January 7, 2008

TEAM UPDATE #1

Important Messages from *FIRST* Headquarters:

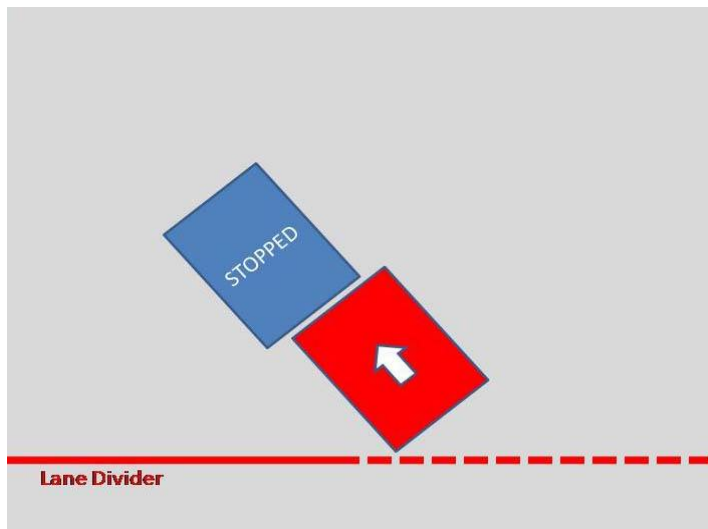
flow of traffic around the TRACK.” That is meant for the entire match. The rest of the rule goes on to define IMPEDING during the Teleoperated Period. Intentionally violating the first sentence of <G40> during the Hybrid Period is against the spirit of the rules.

Robots that come to rest AFTER they have completed some other actions in Hybrid Mode (e.g. crossed one or more lines, attempted to knock down the Trackball, etc.) in a position that might impede other robots will not be penalized. This is consistent with the revised rules, and our intent of the rule. It encourages them to do something during Hybrid Mode, without demanding that they have total field state knowledge. However, robots that intentionally establish a position designed to impede or block traffic WITHOUT doing anything else (e.g. they just drive forward and stop at the corner of the Lane Divider) will be given a yellow card.

This is consistent with the previous Q&A answer we gave. We think there is enough distinction between the two alternatives that teams will understand the difference.
